**THE COMMONWEALTH OF MASSACHUSETTS  
UNIVERSITY OF MASSACHUSETTS AMHERST  
PHYSICAL PLANT BUILDING  
PHYSICAL PLANT DIVISION  
360 CAMPUS CENTER WAY  
AMHERST, MASSACHUSETTS 01003-9248**

**ADDENDUM # 1**

**Re: Project: UMAPP12-031  
W.O. #: 11-027065-000  
Account: 105087  
Title: Taylor Field – Design & Install Photovoltaic Array**

# UMass Hadley Equine and Livestock Farm

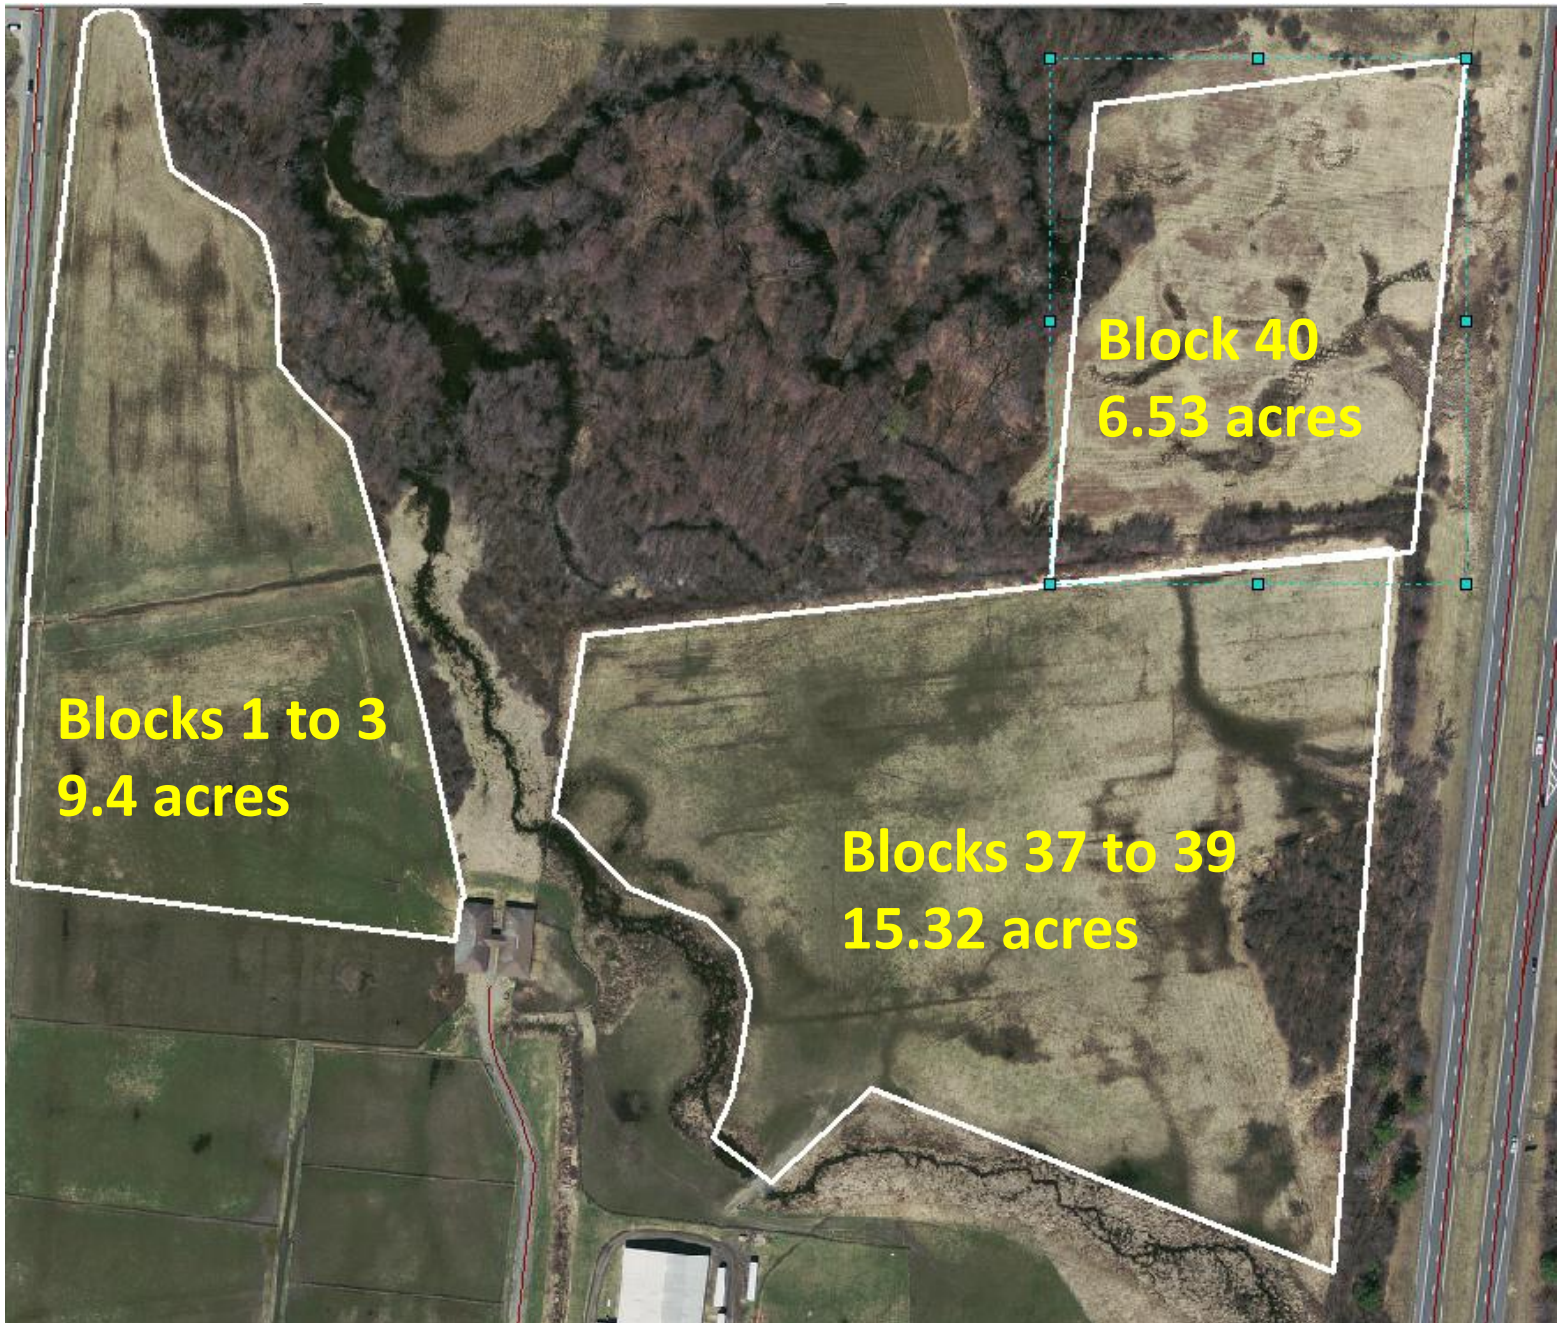
Item #1: Reference the contract title **Taylor Field – Design & Install Photovoltaic Array**, and change to **Hadley Farm – Design & Install Photovoltaic Array**. The Taylor Field site will no longer be used for the PV project. Instead three field sites are available at the Hadley Farm on North Hadley Road in Hadley, Massachusetts. These field sites consist of Blocks 1-3, Blocks 37-39, and Block 40, and are shown on the attached Hadley Farm maps.

Item #5: Reference **PART 5 ATTACHMENTS, 5.0 ATTACHMENTS**, Section **B. Campus Maps**, delete all, and replace with the attached (3) Hadley Farm Maps.

**Block 40**  
**6.53 acres**

**Blocks 1 to 3**  
**9.4 acres**

**Blocks 37 to 39**  
**15.32 acres**

620x400 ft  
50 clusters/row  
X 31 rows  
(20ft between rows)

540x440 ft  
55 clusters/row  
X 30 rows  
(18ft between rows)

1000ft wide with 125 clusters X 12 rows (20ft between rows)  
= 1500 cluster plus 350 in upper triangle = 1850 clusters  
Total panels = 1850 X 4 = 7400 Blocks 37,38,39

## Detailed layout of 4-panel clusters showing 1ft and 2ft spacings between panel clusters.

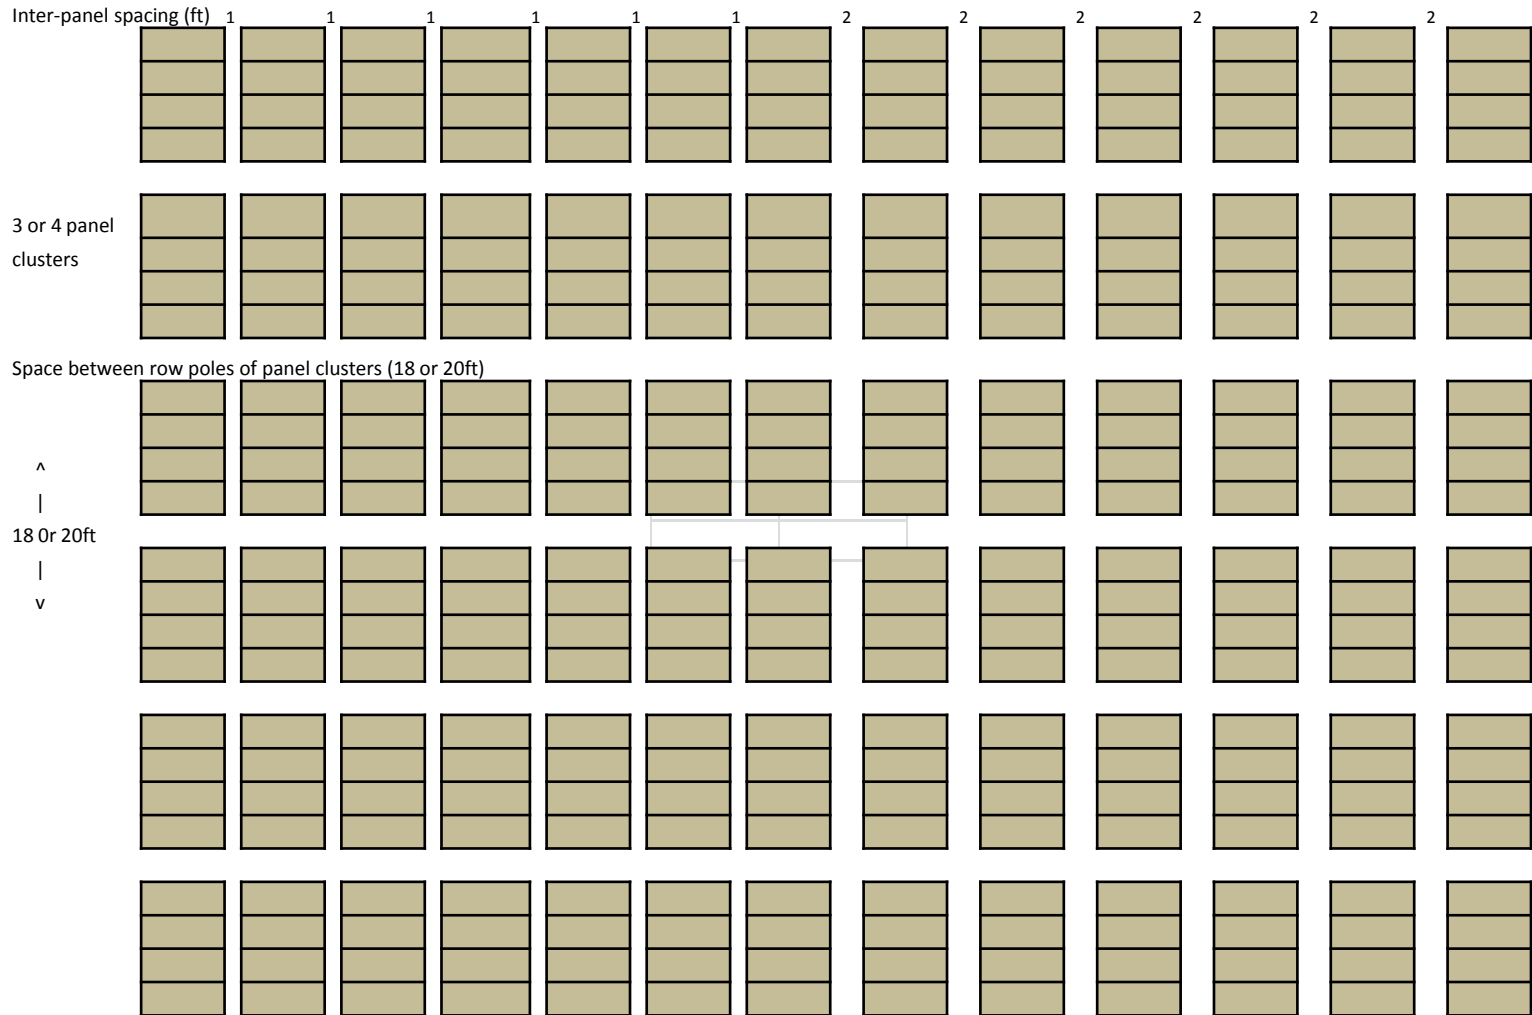
Item #6: Reference **PART 5 ATTACHMENTS, 5.0 ATTACHMENTS**, add Section **E. Detailed layout of 4-panel clusters showing 1ft and 2ft spacings between panel clusters and Schematic of field layout of randomized replicates of each spacing**, which are attached to this addendum.

Similar for 3ft and 4ft interpanel spacings. Minimum of 6 interpanel spacings of each distance and 6 rows of each spacing. These 6 rows of each spacing would be repeated in a randomized way throughout the field. See schematic below of field layout of each spacing x 6 rows.

(minimum of 6 rows of panel clusters for each spacing - replicates of spacings repeated throughout the field – UMass will assist with this layout in fields)
